Comment r01-18

Pete Anslow, Ciena

IEEE P802.3 (IEEE 802.3cj) Task Force, Rosemont, March 2018

Figure 121-7—Illustration of receiver sensitivity

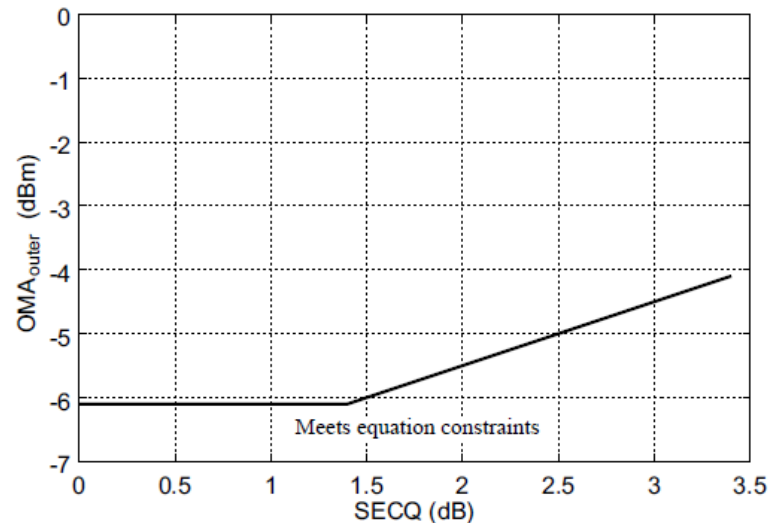
Changes to 121.8.8

Receiver sensitivity, which is defined for an input signal with SECQ of 0.9 dB (e.g., an ideal input signal without overshoot), is informative and compliance is not required. If measured, the test signal should have negligible impairments such as intersymbol interference (ISI), rise/fall times, jitter and RIN. Instead, the normative requirement for receivers is stressed receiver sensitivity.

Receiver sensitivity is informative and is defined for a transmitter with a value of SECQ up to 3.4 dB. Receiver sensitivity should meet Equation (121-13), which is illustrated in Figure 121-7.

$$RS = \max(-6.1, SECQ - 7.5) \text{ (dB)} \quad (121-13)$$

The normative requirement for receivers is stressed receiver sensitivity.

Figure 122-6—Illustration of receiver sensitivity for 200GBASE-FR4 and 200GBASE-LR4

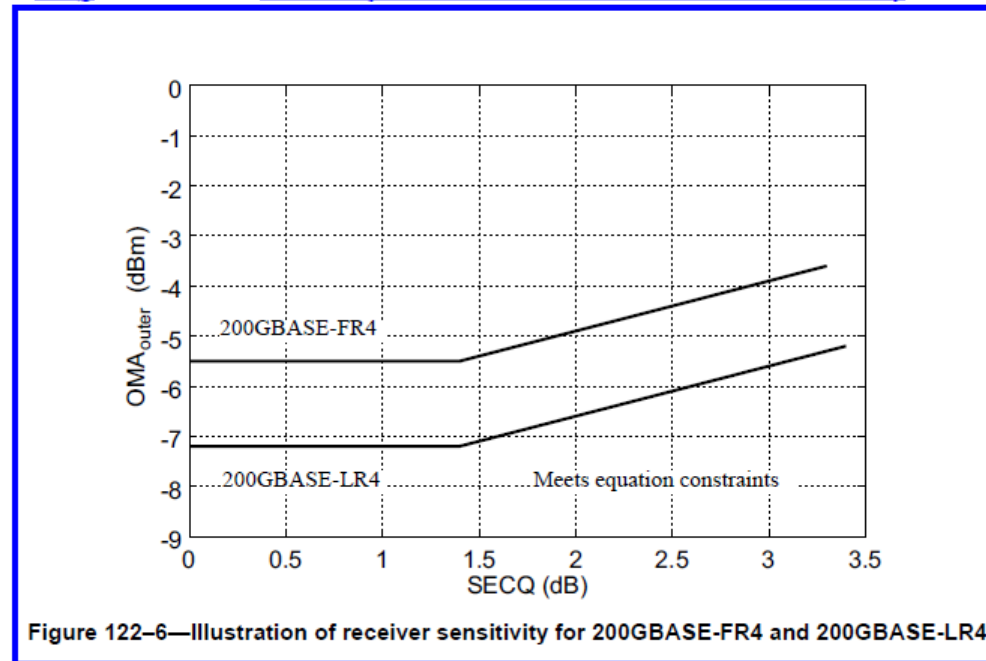
Changes to Table 122.8.8 part 1

Receiver sensitivity, which is defined for an input signal with SECQ of 0.9 dB (e.g., an ideal input signal without overshoot), is informative and compliance is not required. If measured, the test signal should have negligible impairments such as intersymbol interference (ISI), rise/fall times, jitter and RIN. Instead, the normative requirement for receivers is stressed receiver sensitivity.

For 200GBASE-FR4, receiver sensitivity is informative and is defined for a transmitter with a value of SECQ up to 3.3 dB. Receiver sensitivity should meet Equation (122-1), which is illustrated in Figure 122-6.

For 200GBASE-LR4, receiver sensitivity is informative and is defined for a transmitter with a value of SECQ up to 3.4 dB. Receiver sensitivity should meet Equation (122-2), which is illustrated in Figure 122-6.

$$RS = \max(-5.5, SECQ - 6.9) \text{ (dB)} \quad (122-1)$$

$$RS = \max(-7.2, SECQ - 8.6) \text{ (dB)} \quad (122-2)$$

Figure 122-7—Illustration of receiver sensitivity for 400GBASE-FR8 and 400GBASE-LR8

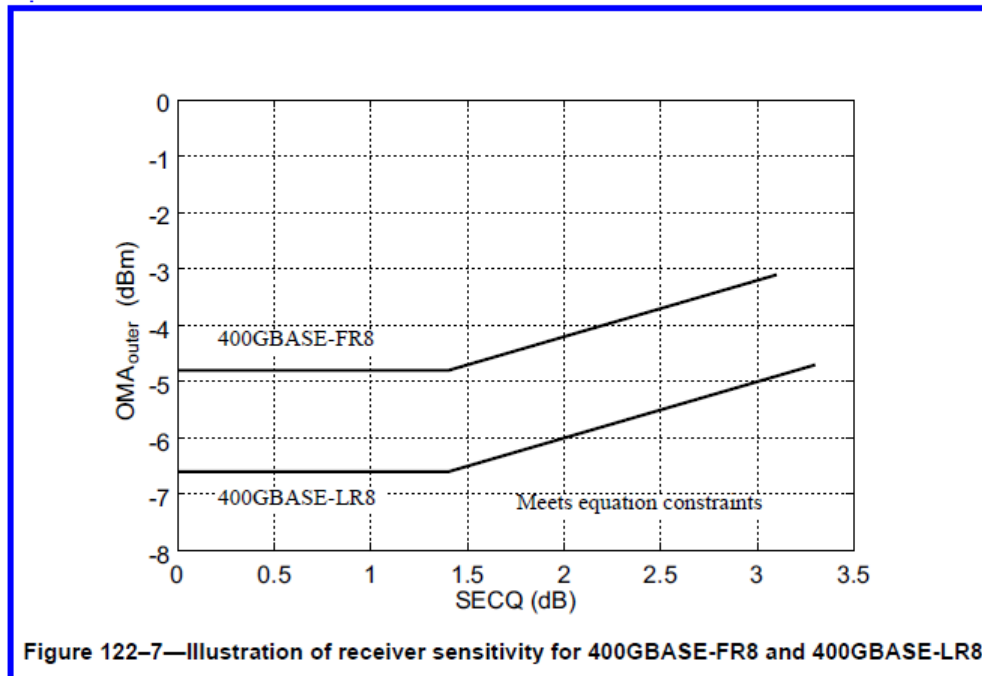
Changes to Table 122.8.8 part 2

For 400GBASE-FR8, receiver sensitivity is informative and is defined for a transmitter with a value of SECQ up to 3.1 dB. Receiver sensitivity should meet Equation (122-3), which is illustrated in Figure 122-7.

For 400GBASE-LR8, receiver sensitivity is informative and is defined for a transmitter with a value of SECQ up to 3.3 dB. Receiver sensitivity should meet Equation (122-4), which is illustrated in Figure 122-7.

$$RS = \max(-4.8, SECQ - 6.2) \text{ (dB)} \quad (122-3)$$

$$RS = \max(-6.6, SECQ - 8) \text{ (dB)} \quad (122-4)$$

Figure 124-4—Illustration of receiver sensitivity

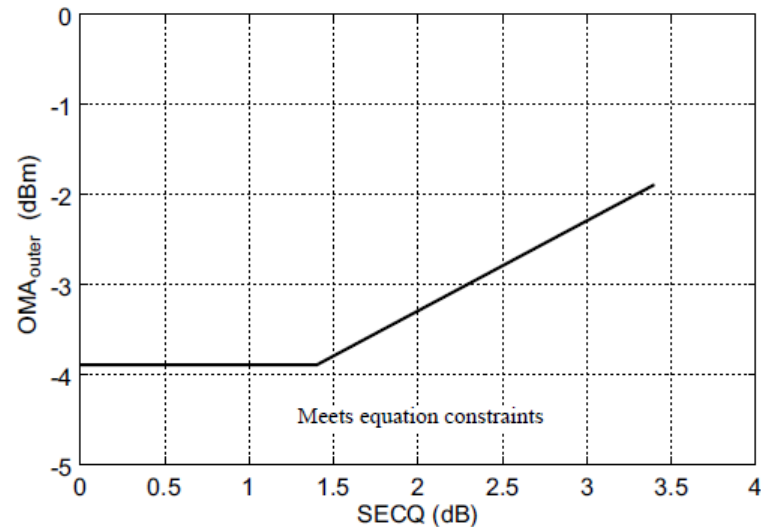
Changes to Table 124.8.8

Receiver sensitivity, which is defined for an input signal with SECQ of 0.9 dB (e.g., an ideal input signal without overshoot), is informative and compliance is not required. If measured, the test signal should have negligible impairments such as intersymbol interference (ISI), rise/fall times, jitter and RIN. Instead, the normative requirement for receivers is stressed receiver sensitivity.

Receiver sensitivity is informative and is defined for a transmitter with a value of SECQ up to 3.4 dB. Receiver sensitivity should meet Equation (124-1), which is illustrated in Figure 124-4.

$$RS = \max(-3.9, SECQ - 5.3) \quad (\text{dB}) \quad (124-1)$$

The normative requirement for receivers is stressed receiver sensitivity.
